Heathrow West Hotel, Longford

Planning application no.65419/APP/2009/2715

Strategic planning application stage 1 referral (new powers)

Figure 4: Block Plans and layout of the proposed hotel development (Source: applicant's design & access statement)

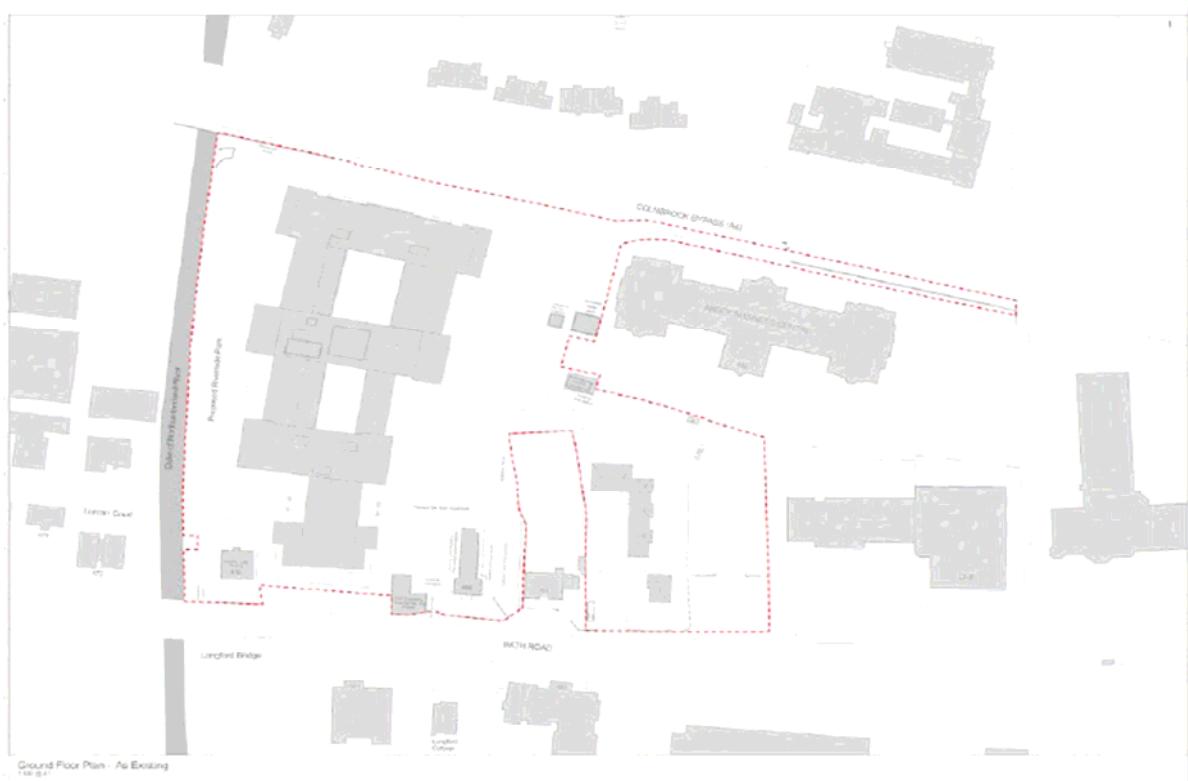
35 The proposed design reflects some of the pre-application advice provided to the applicant although there remain areas for improvement and further clarification. The proposed layout as shown in Figure 4, and the distribution of scale and massing broadly responds to the varied context of site. Most importantly the scale of development fronting Bath Road reflects the character of that route and the domestic scale of the Grade II listed 456 Bath Road. The Council should consider the acceptability of the detail of the proposals relating to this listed building though review of the relevant application and also the impact on the setting of the locally listed building in the vicinity.
